Access Compliance Report Public Rights-of-Way (Curb Ramps)

Main Street: MARKHAM_LN Cross Street: CALDWELL_LN Location: SW

ADA ID: RPAT211103113332 Ramp Type: Type 4 - Parallel Initial Pass/Fail: Fail Overall Compliance: No Severity Score: 15

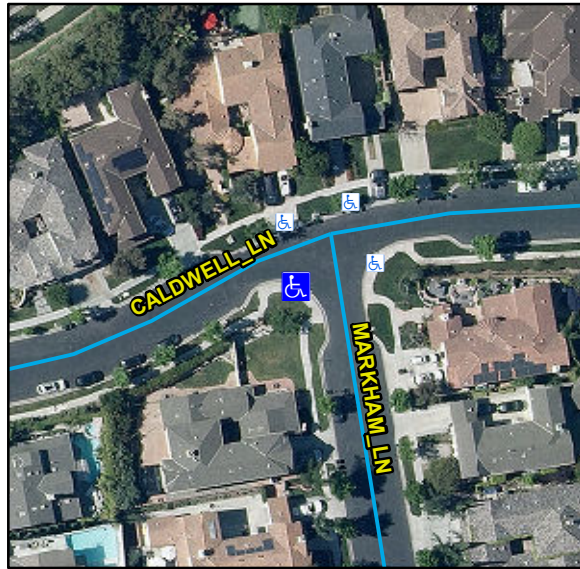
Compliance	Description	Data	Compliance	Description	Data
N/A	Ramp Length LT (in)	100	N/A	Ramp Length RT (in)	103
Yes	Ramp Width LT (in)	53	Yes	Ramp Width RT (in)	53
Yes	Ramp Run Slope LT (%)	0.8	No	Ramp Run Slope RT (%)	11.9
Yes	Ramp Cross Slope LT (%)	1.2	Yes	Ramp Cross Slope RT (%)	1.5
N/A	Landing Present	N/A	N/A	DWS Provided	N/A
N/A	Landing Length (in)	N/A	N/A	DWS Contrast	N/A
N/A	Landing Width (in)	N/A	N/A	DWS Length (in)	N/A
N/A	Landing Run Slope (%)	N/A	N/A	DWS Full Width	N/A
N/A	Landing Cross Slope (%)	N/A		DWS Offset Type	N/A
N/A	Landing Movement Obstructed?	N/A	N/A	DWS Offset Left (in)	N/A
	Landing Movement Type	N/A	N/A	DWS Offset Right (in)	N/A
N/A	Landing Shared	N/A			
N/A	Clear Space	Yes			
N/A	Clear Space To Crosswalk (in)	N/A			
N/A	Marked Crosswalk 1	No	N/A	Marked Crosswalk 2	No
	Crossing 1 Direction	E		Crossing 2 Direction	N
N/A	Marked Crosswalk 1 Width (in)	N/A		Marked Crosswalk 2 Width (in)	N/A

Remove & Replace Curb Ramp With Two New Directional Ramps or Equivalent.

R204.3, R304.3.2, STD 1115
